ADDENDUM NO. 1

PROJECT NO. SP 20-6 GREENWOOD CULTURAL CENTER FACILITY REHABILITATION

ADDENDUM NO. 1 TO PROJECT NO. SP 20-6 GREENWOOD CULTURAL CENTER FACILITY REHABILITATION

Addendum No.: 01

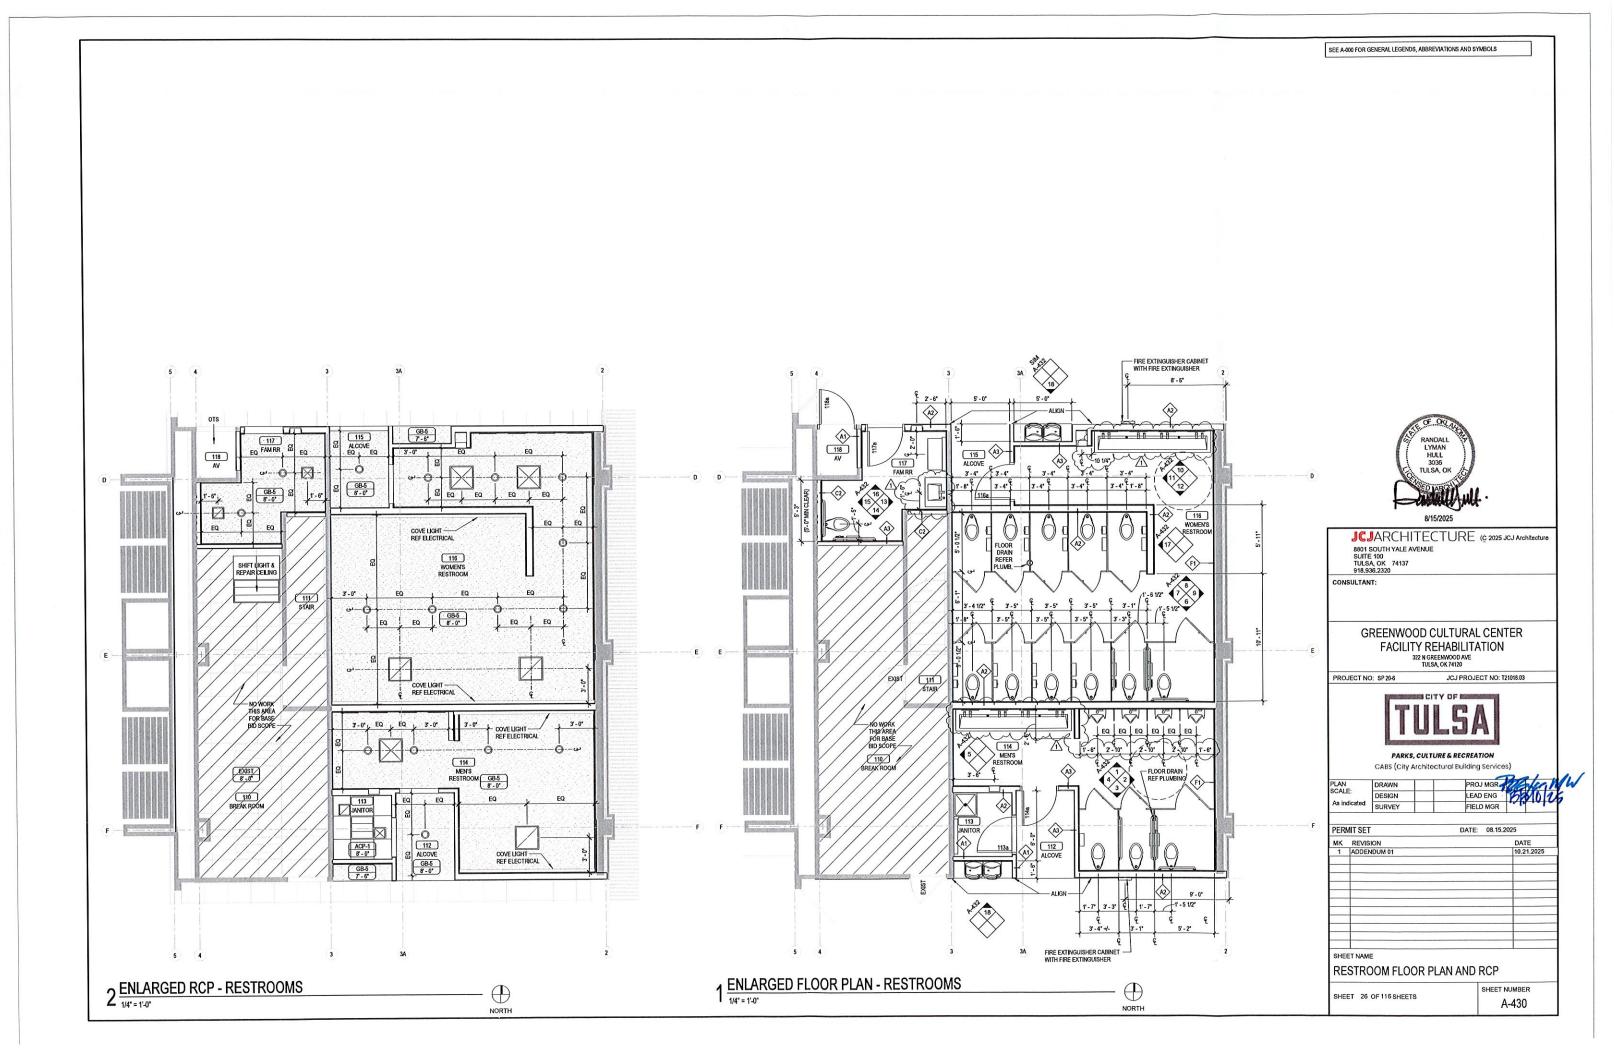
- 1. A-430 RESTROOM FLOOR PLAN AND RCP
 - Drawing 1 Revised lavatory decks and dimensions at Men's Restroom, Women's Restroom, and Family Restroom.
- 2. A-432 RESTROOM ELEVATIONS
 - a. Drawings 1, 10, 13 Revised lavatory deck and dimensions
- 3. P-600 PLUMBING SCHEDULES BASE BID
 - a. FIXTURE SCHEDULE Revised lavatory decks, faucets, and soap dispensers
